September 6, 2024

**Re: Initial Submission Review:** Windler Midtown – Site Plan (Neighborhood Plan Pilot)  
**Application Number:** DA-1707-38  
**Case Numbers:** 2024-4021-00

WINDLER MIDTOWN  
NEIGHBORHOOD PLAN

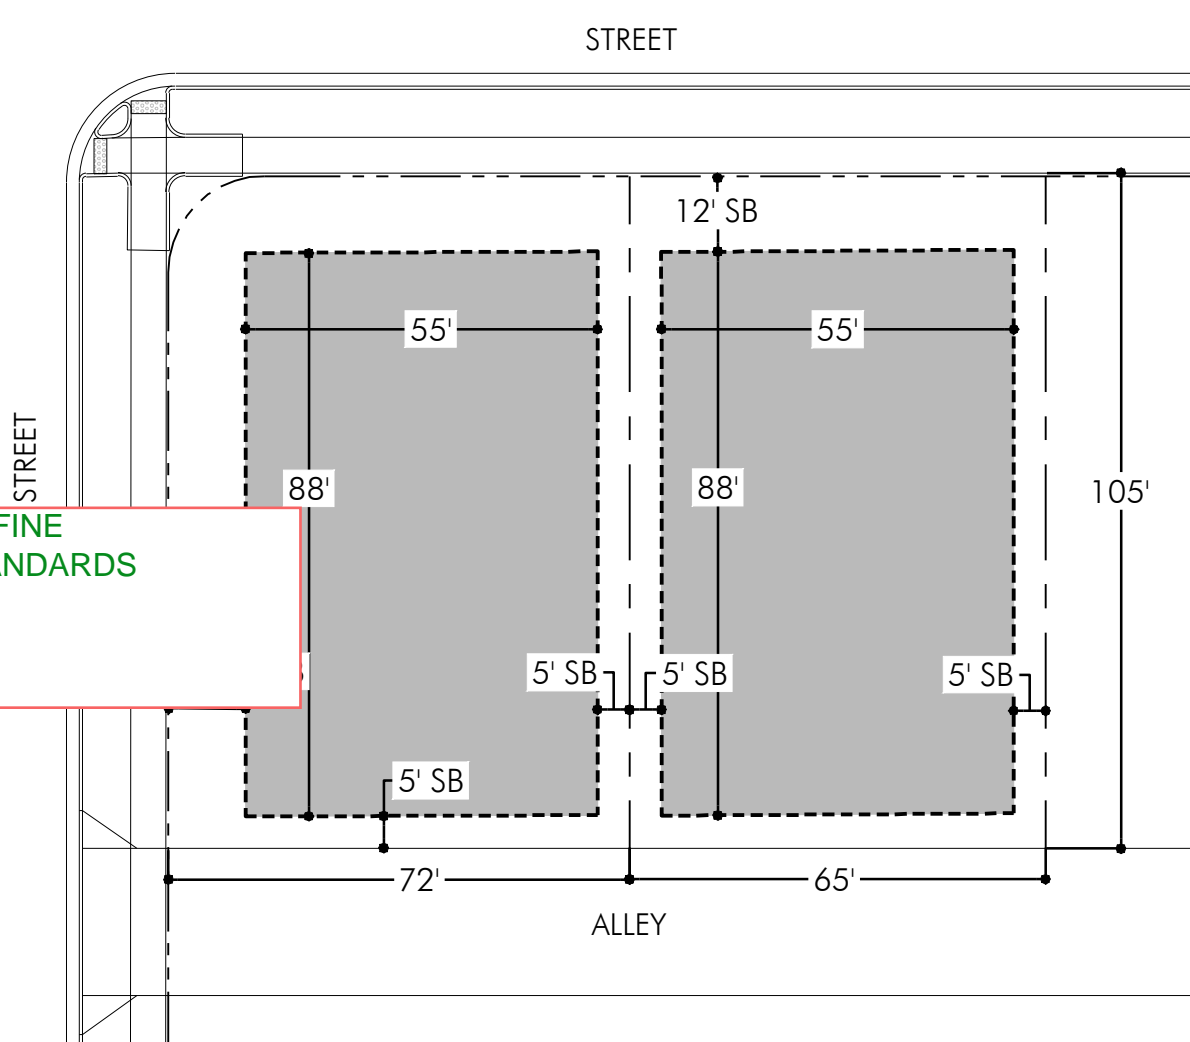
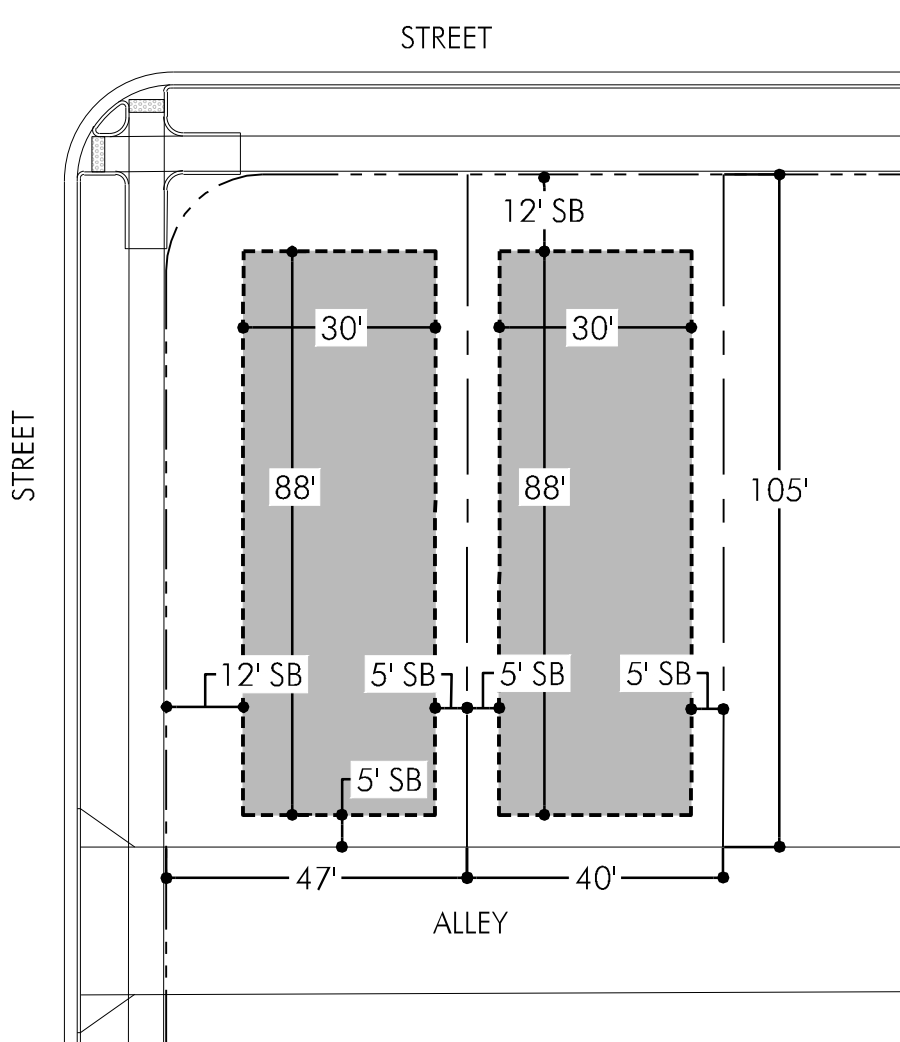
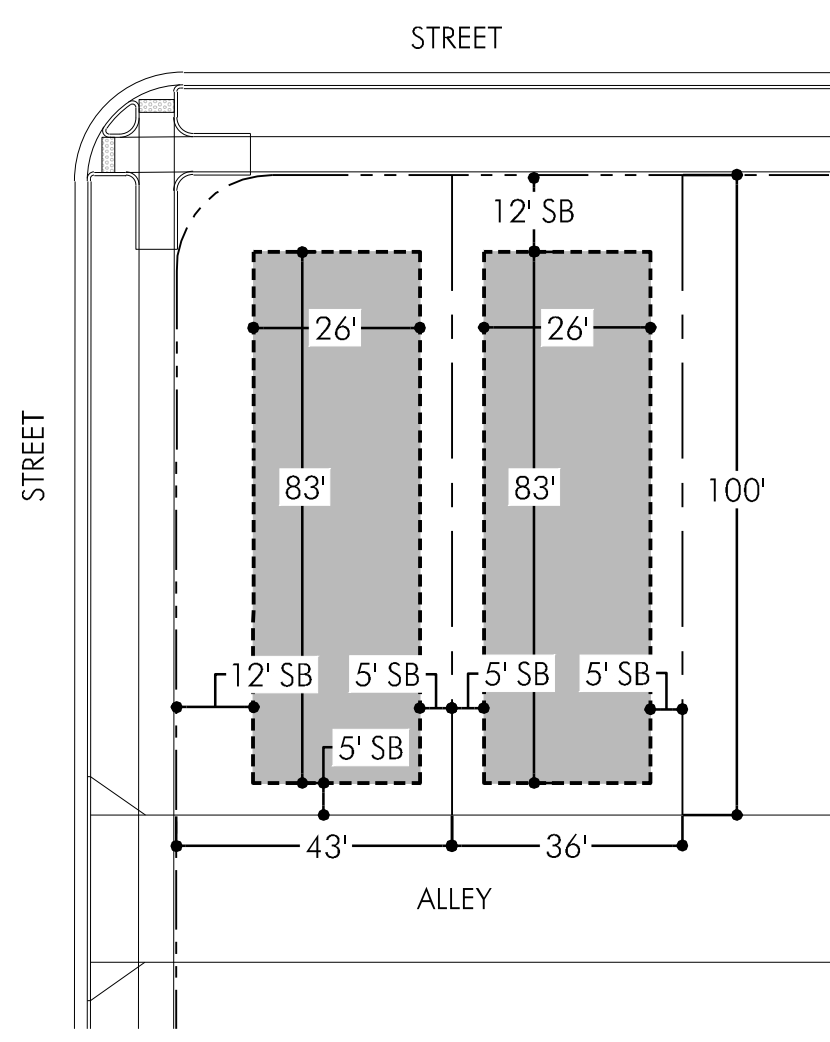
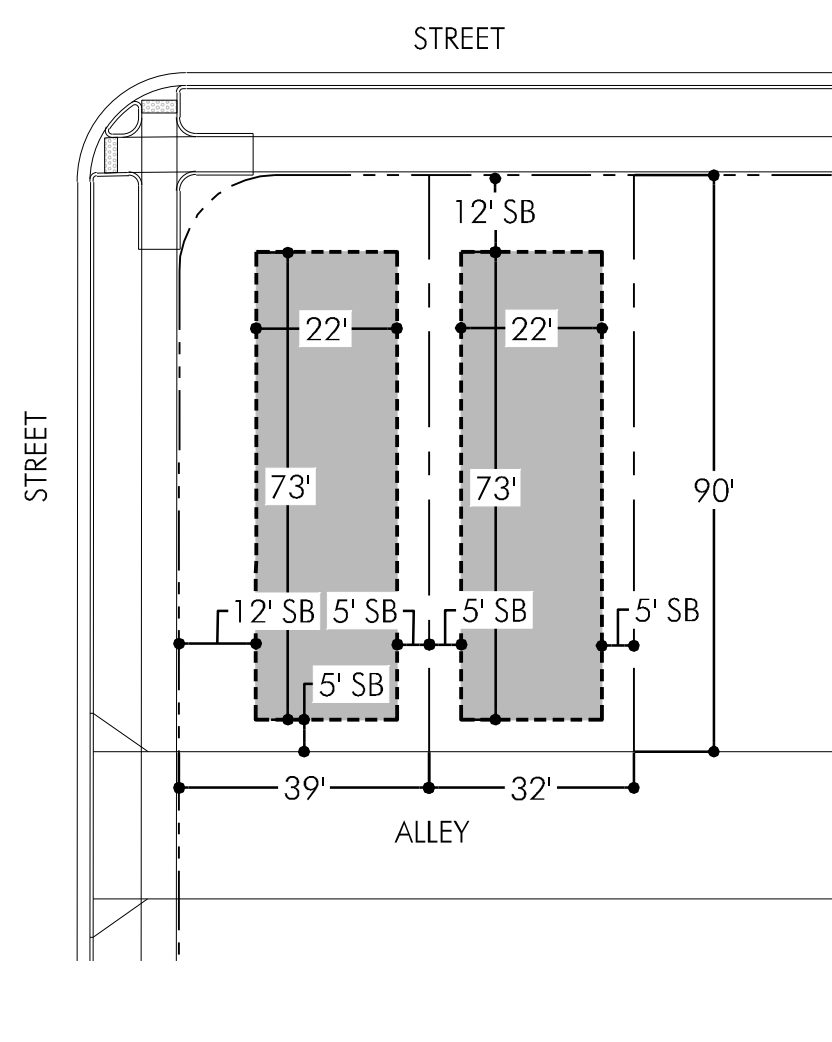
A NOTE HAS BEEN ADDED TO DEFINE GREENCOURT DIMENSIONAL STANDARDS

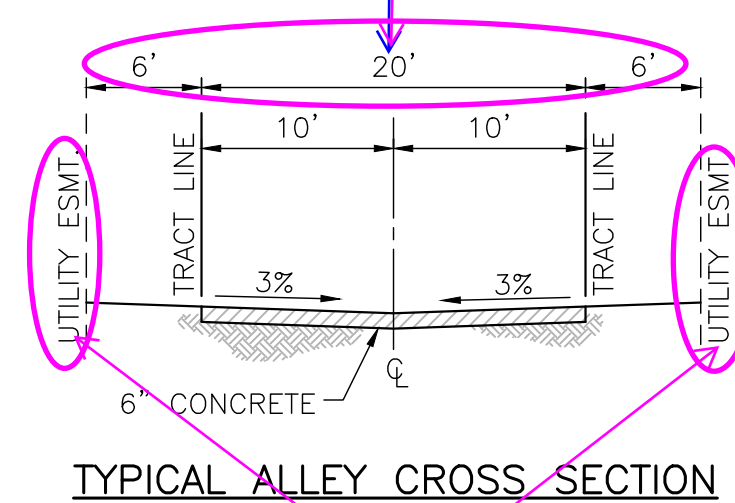
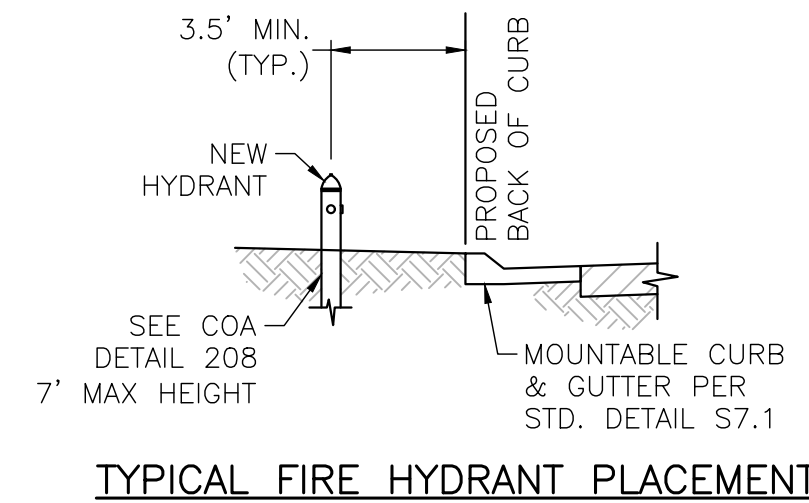
Clarify, by name, which street will be constructed to which section shown on this sheet.

Why are sections identified as primary pedestrian connections and using urban street sections identified as "low pedestrian activity levels"?

these total 32' where the graphic total is 26'

MM Response: Street names added.

MM Response: Pedestrian activity levels removed. Previous projects have asked for this to be added per COA Roadway Standards 4.10.4.04.01

MM Response: Updated

Fire lane sign details  
and notes.

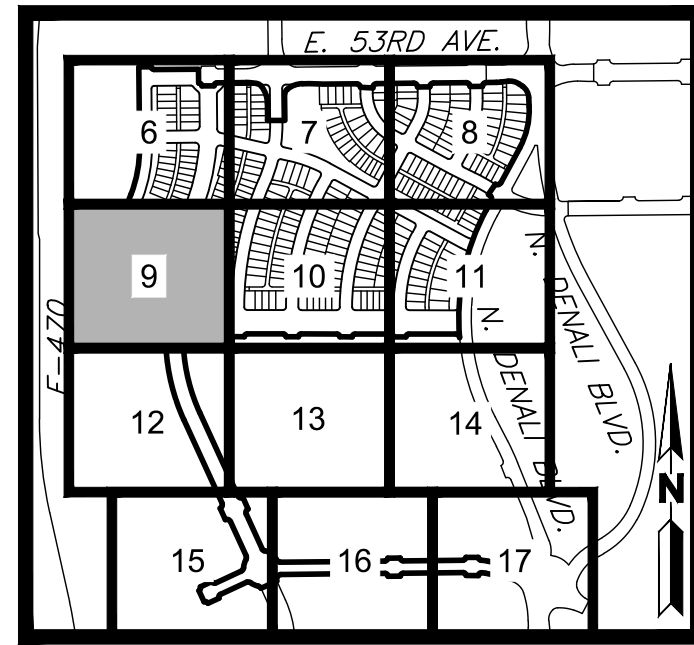
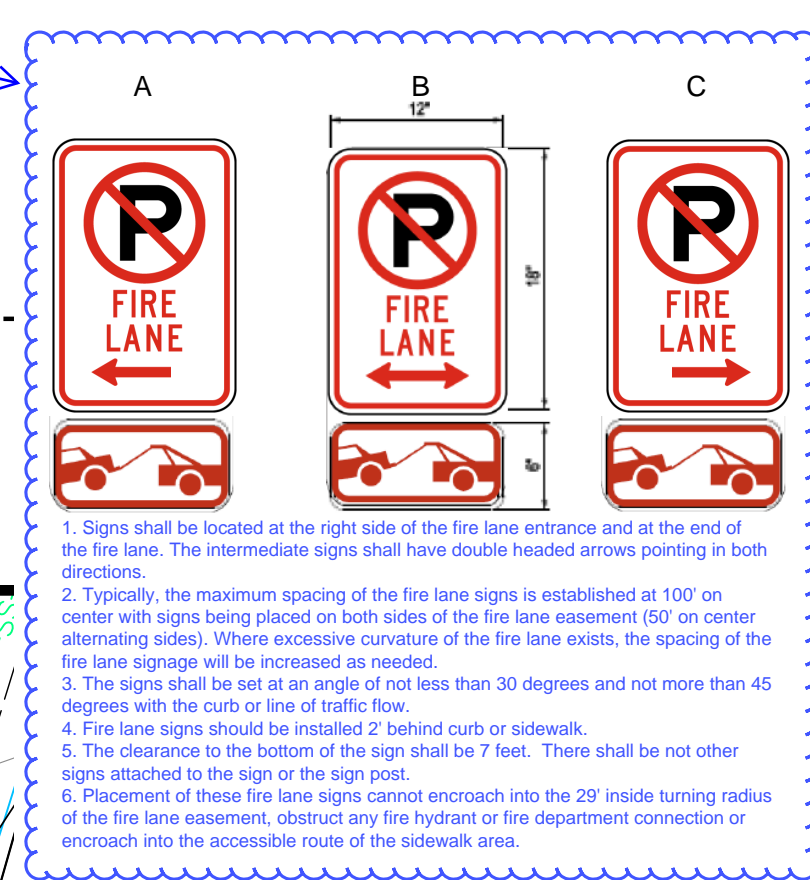
Show fire lane sign in the legend.

MM Response:  
Added.

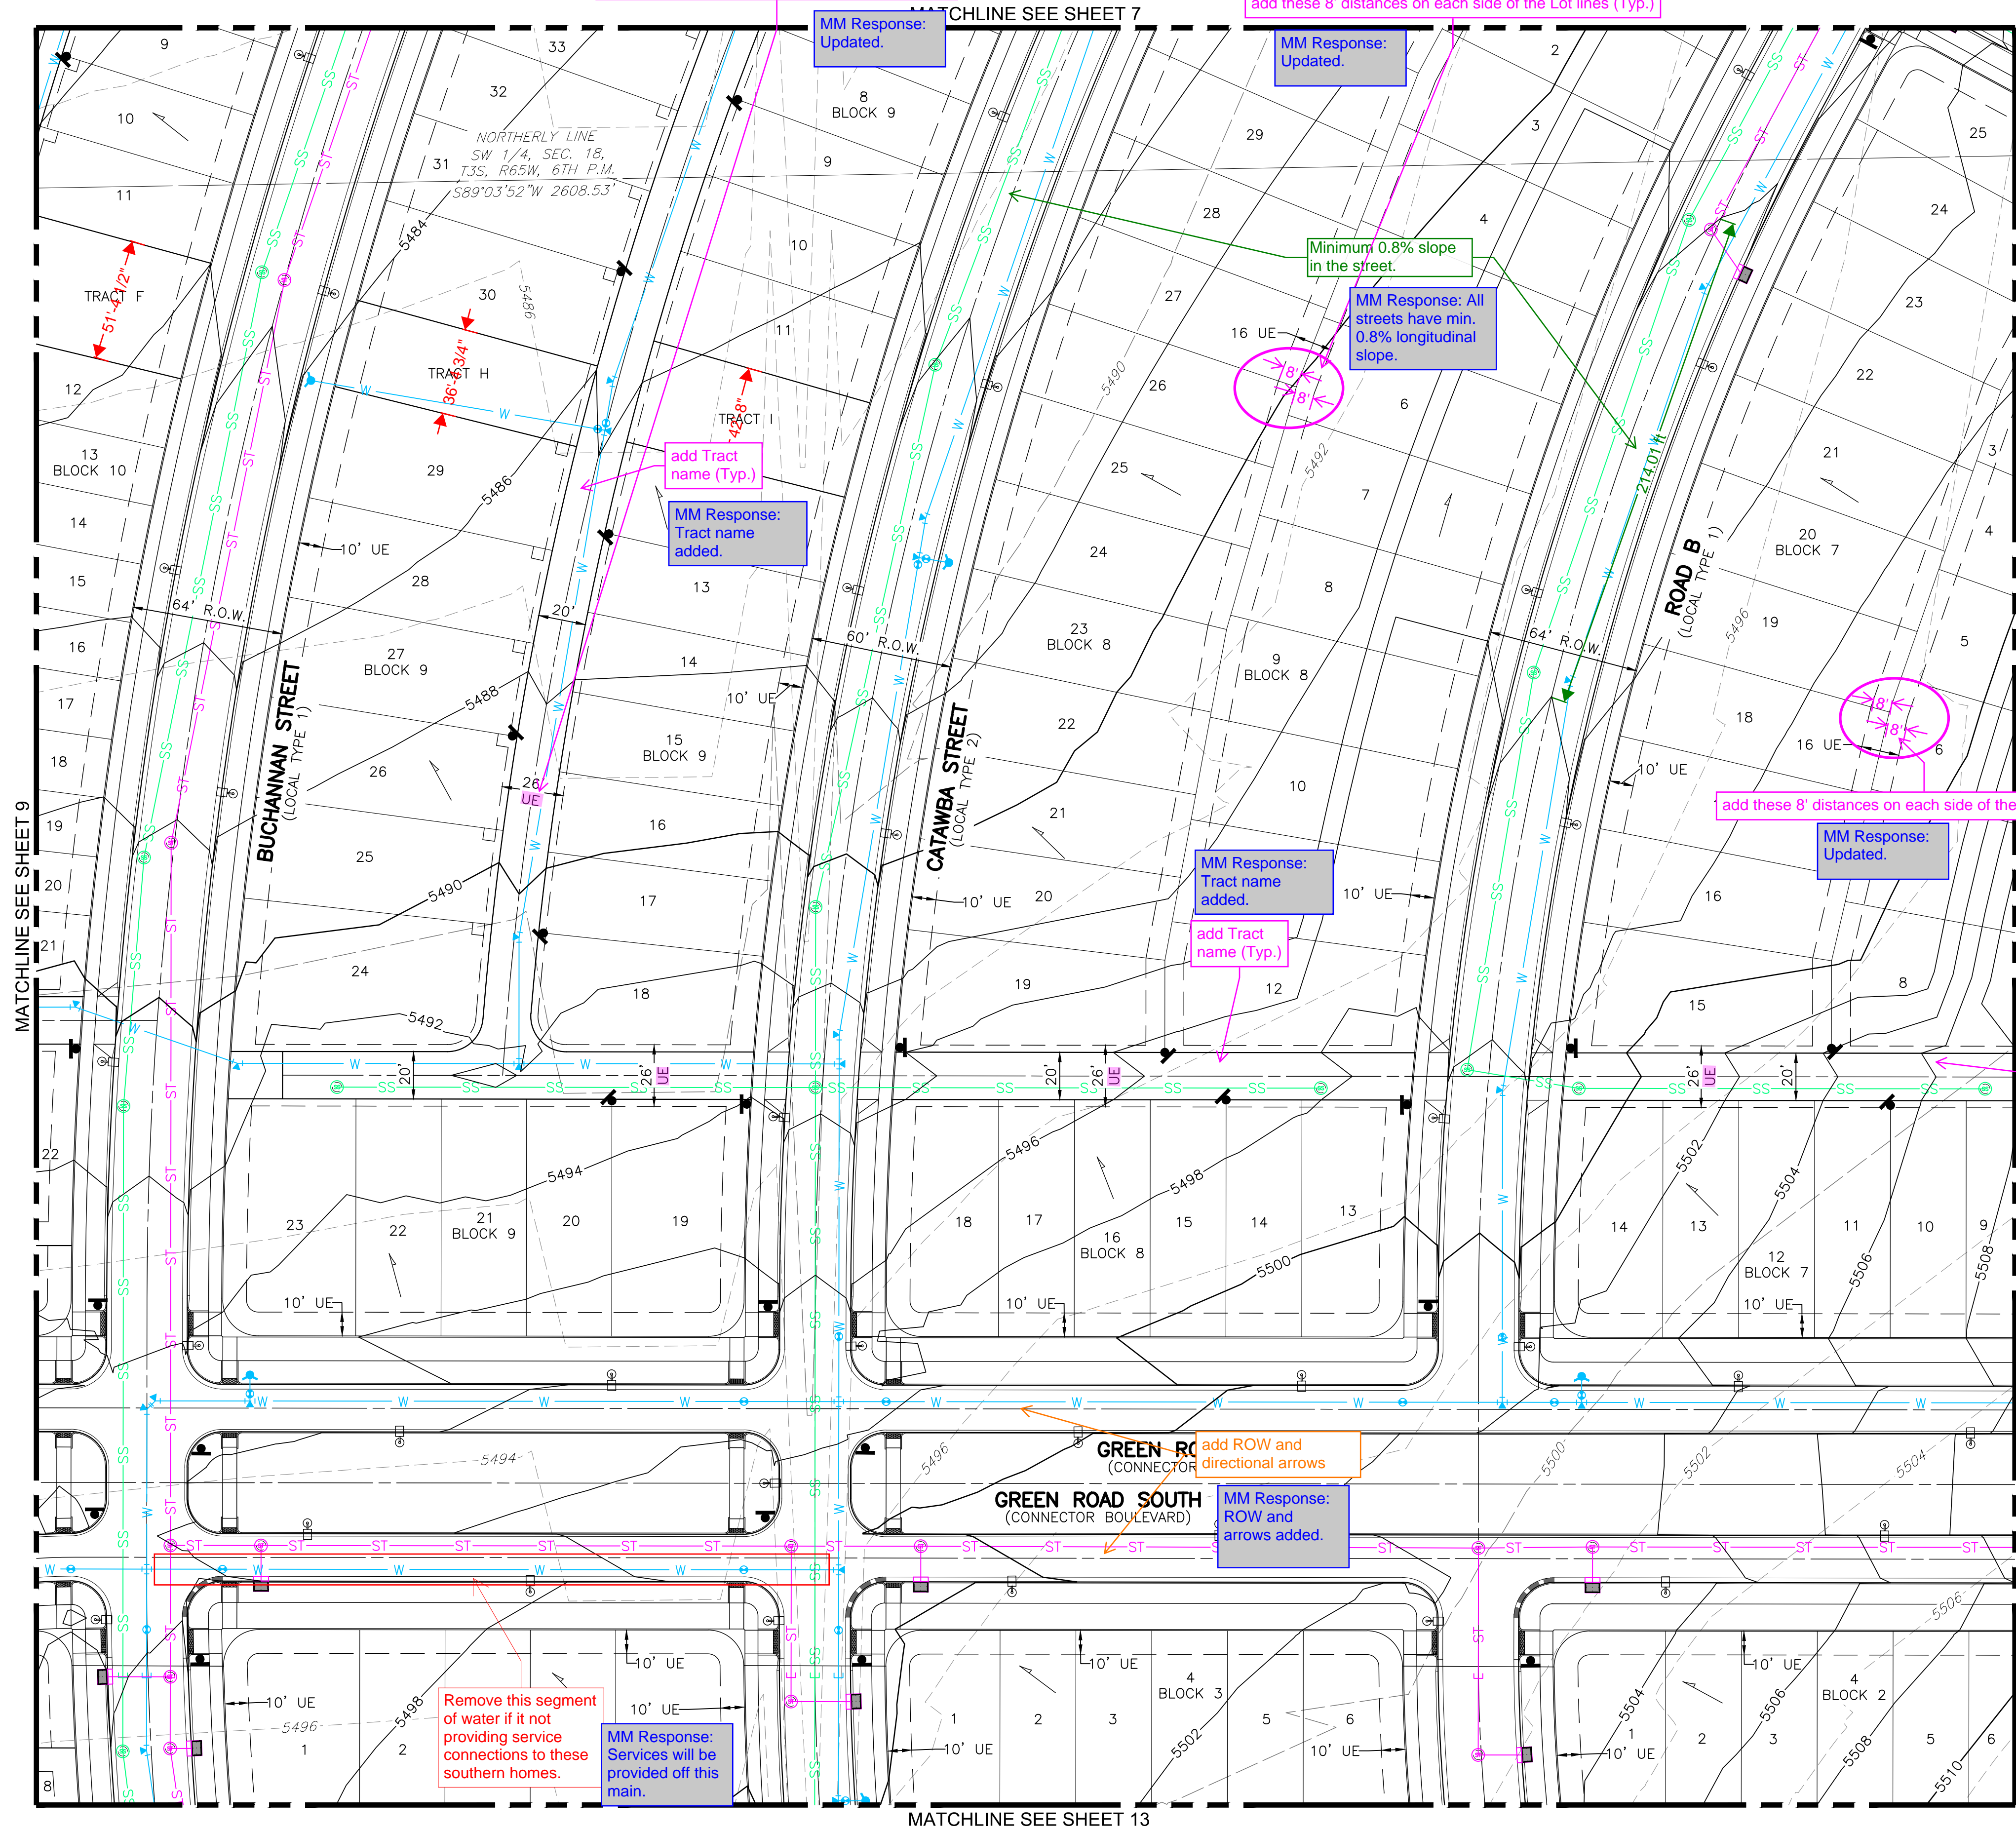
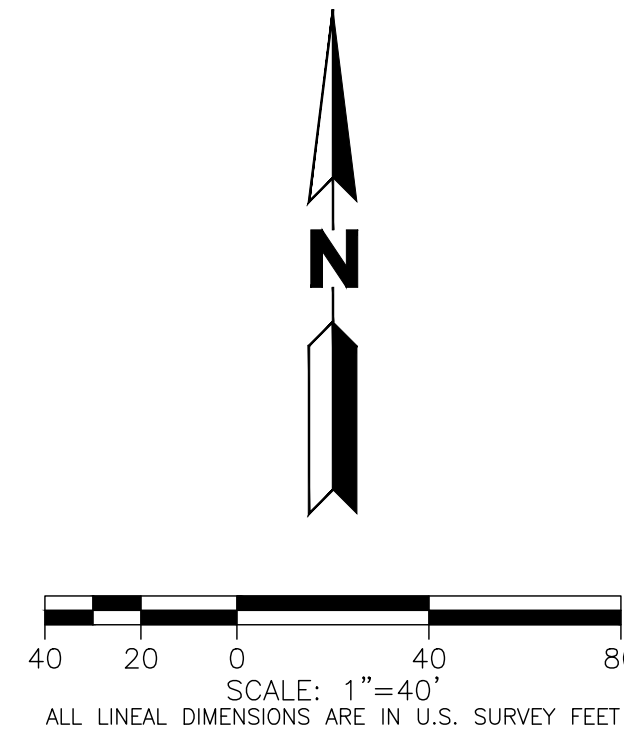
change these U.E. to the type of Water feature located within; this data that should match the plat exactly. (Typ.) (Confirm the naming with Aurora Water Dept.)

add other abbreviations here

MM Response: Abbreviations added.
